NL-11-049

SUBJECT: Revised Core Operating Limits Report
Indian Point Nuclear Generating Unit No. 3
Docket No. 50-286
License No. DPR-64

3-GRAPH-RPC-16, Rev. 3, Core Operating Limits Report

3-GRAPH-RPC-16, Rev. 4, Core Operating Limits Report

Figure 1
Reactor Core Safety Limit – Four Loops in Operation

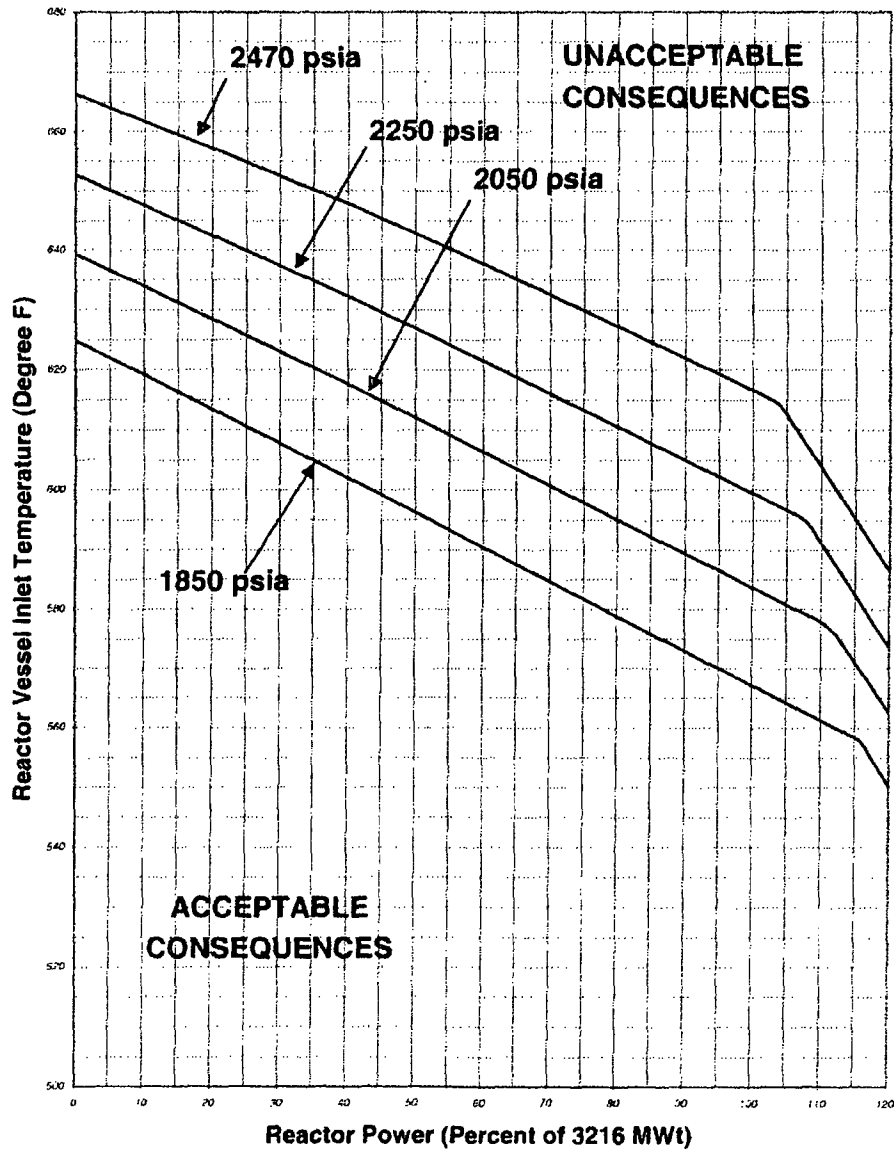
- 2.9 Changed Labeling on Figure1 from ACCEPTABLE/ UNACCEPTABLE OPERATION to ACCEPTABLE/ UNACCEPTABLE CONSEQUENCES
- 2.10 Added Power Level and Tech Spec Envelope values to Figure 4
